Walking-Working Surfaces, Personal Protective Equipment (Fall Protection Systems), and Special Industries (Electric Power Generation, Transmission, and Distribution); Corrections

ACTION: Final rule; corrections to standards.

SUMMARY: OSHA is issuing corrections to the Walking-Working Surfaces, Personal Protective Equipment, and Special Industries standards.

Figure D-8 – Dimensions of Standard Stairs

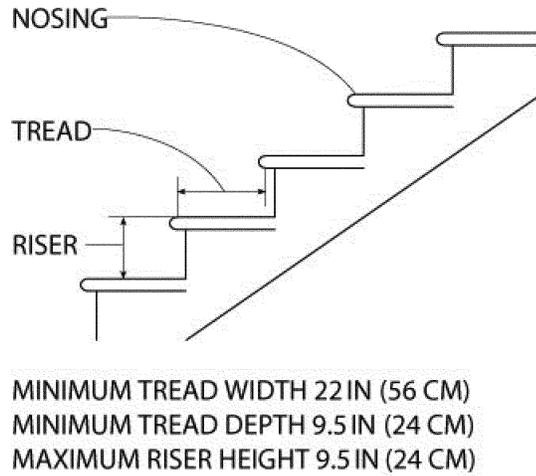
The figure at 29 CFR 1910.25(c) immediately after Table D-1 does not have a title even though it is referred to as Figure D-8 in § 1910.25(c)(4). The title of the figure was included in the proposed rule (75 FR at 29137) but mistakenly left out of the final rule (81 FR at 82989). This document adds the missing title to the figure: “Figure D-8—Dimensions of Standard Stairs”.

■ 3. Amend § 1910.25 by revising paragraph (a) and the figure following Table D–1 in paragraph (c)(5) to read as follows:

Figure D-11 Guardrail Systems

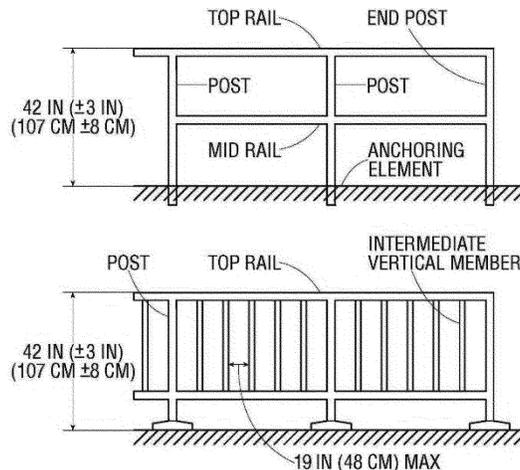
OSHA is correcting Figure D-11 to include labels identifying the top rail and end post in the top diagram of the figure. The words “top rail” and “end post” were mistakenly omitted when the final rule was published in the **Federal Register** (81 FR at 82995).

■ 5. Amend § 1910.29 by revising paragraph (b)(1) and Figure D-11 to read as follows:

(1) The top edge height of top rails, or equivalent guardrail system members, are 42 inches (107 cm), plus or minus 3 inches (8 cm), above the walking-working surface. The top edge height may exceed 45 inches (114 cm), provided the guardrail system meets all other criteria of paragraph (b) of this section (see Figure D-11 of this section).
